Subject: RE: NYM/2021/0597/FL 6 Prospect Field, High Hawsker E12137-16 NYMNPA reved dwg 10.03.22

Mr K & Mrs S Simpson

6 Prospect Field

Proposed Plans and Elevations

D12137-03

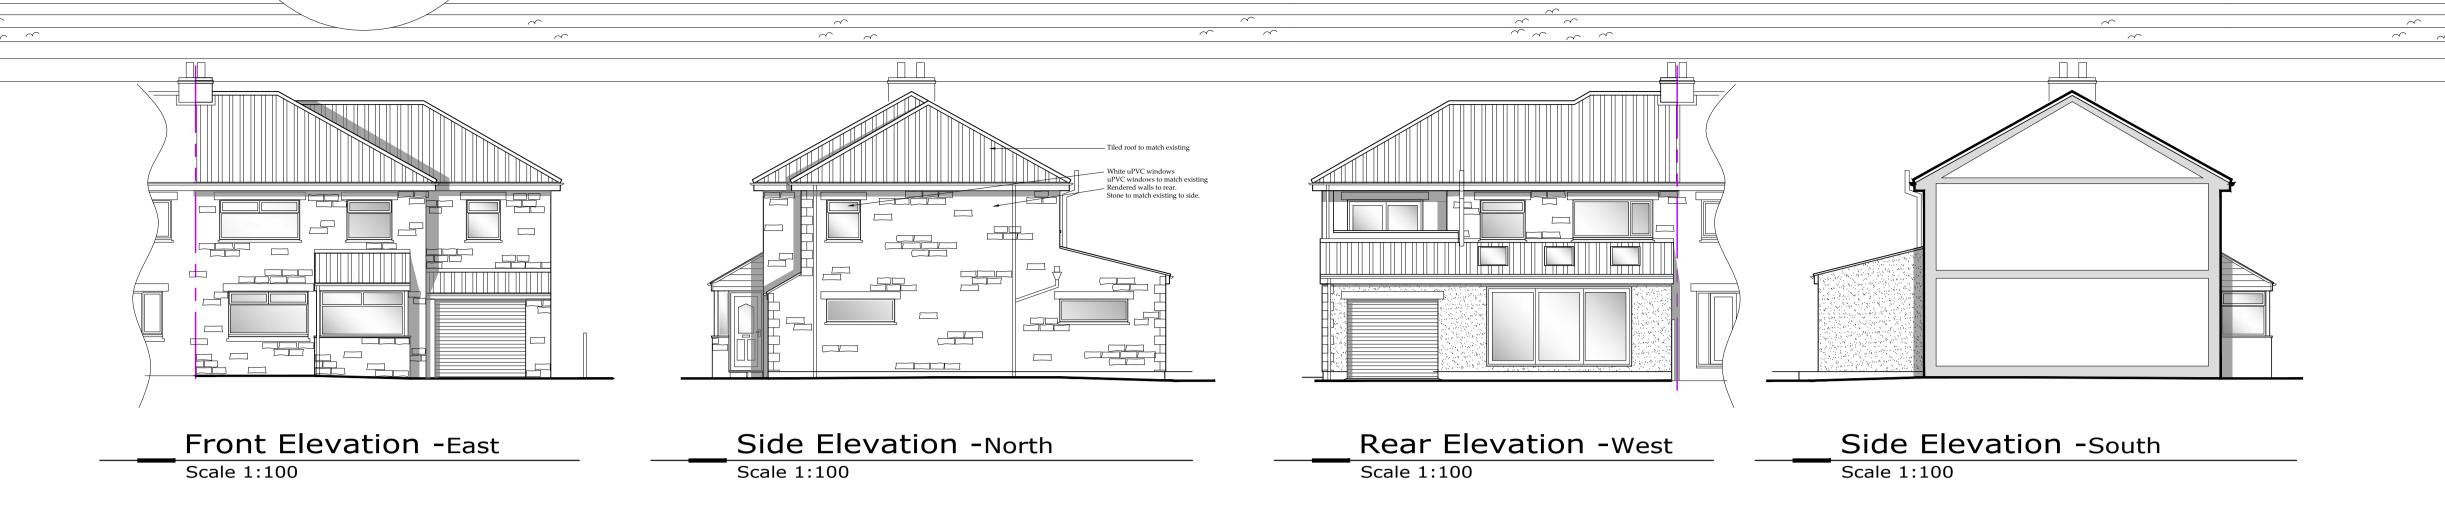
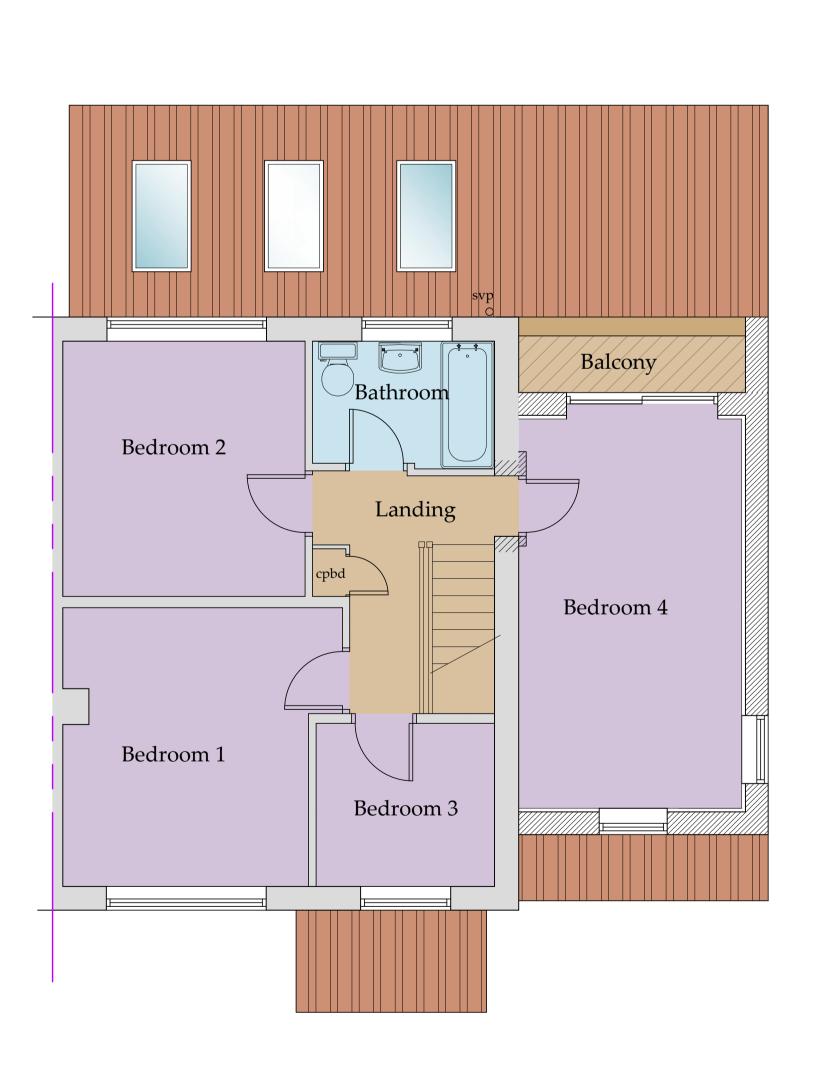
I have had a chat with the clients and they are willing to infill the wall to the side of the Balcony area. The attached drawing confirms this alteration.

F 10/03/22 CE Balcony wall amended E 27/01/22 CE Reduced D 06/12/21 CE Amended to suit client C 03/11/21 CE Balcony reduced B 26/07/21 CE Amended to suit client comments A 13/07/21 CE Issued for approval
